Sub.: Modification Sheet for development of Traction Motor Dropping Detection System (TMDDS) in WAP-7/WAG-9, WAG-9H, WAG9HC type of Electric Locomotives.

Modification Sheet No. RDSO/2023/EL/MS/0496 Rev '0' Dated: 01.12.2023

- **1.0 Title:** Modification Sheet for development of Traction Motor Dropping Detection System (TMDDS) in WAP-7/WAG-9/9H/9HC type of Electric Locomotives.
- **2.0 Object:** There is no indication for loco crew in three phase Electric Locos regarding falling of TM on-line.In view of criticality of the issues it has been felt necessary to develop Traction Motor Dropping Detection System (TMDDS) in WAP-7/WAG-9/9H/9HC type of Electric Locomotives.
- **3.0 Existing Arrangement:** The ABB traction motor type 6FRA 6068 used in WAP-7/ WAG-9/9H/9HC Locos are suspended in the bogie frame from torque arm through motor support and TM holder plate and on the individual axles through suspension tube.

QEMS RELAY FOR TMDDS

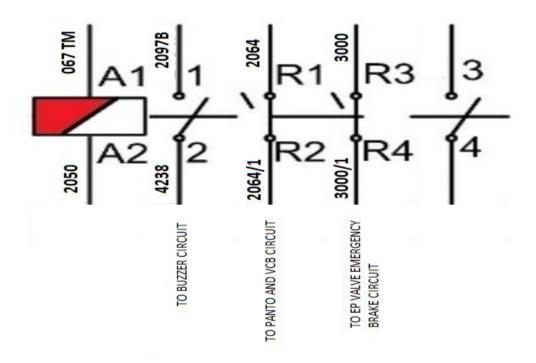
CABLE INDEX FOR QEMS RELAY

1. FOR PANTO AND VCB CIRCUIT

2064 XK77A 01 W03 → 2064 XF77S 01 SPARE WAGO SB-2 → 2064 QEMS - R1 2064 XF 77S 01:01 ← 2064/1 QEMS - R2

2. FOR BUZZER CIRCUIT

2097B XF77S 03:02 → 2097B QEMS - 01 4238 XF77S 02:38 ← 4238 QEMS - 02

3. FOR EP VALVE EMERGENCY BRAKE CIRCUIT

3000 XK77V 02:05 → 3000 XF77S 01 SPARE WAGO SB-2 → 3000 QEMS – R3 3000 XF77S 01:16 ← 3000/1 QEMS – R4

PHOTOGRAPHS OF 3-PHASE LOCO TMDDS MODIFICATION

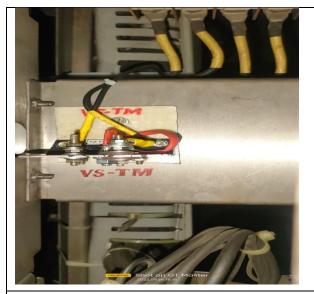
QEMS –LCD 128

MCB TMDDS

LSTM ON D PANEL

DIODE VSTM

BODY TO BOGIE 2 PIN COUPLER
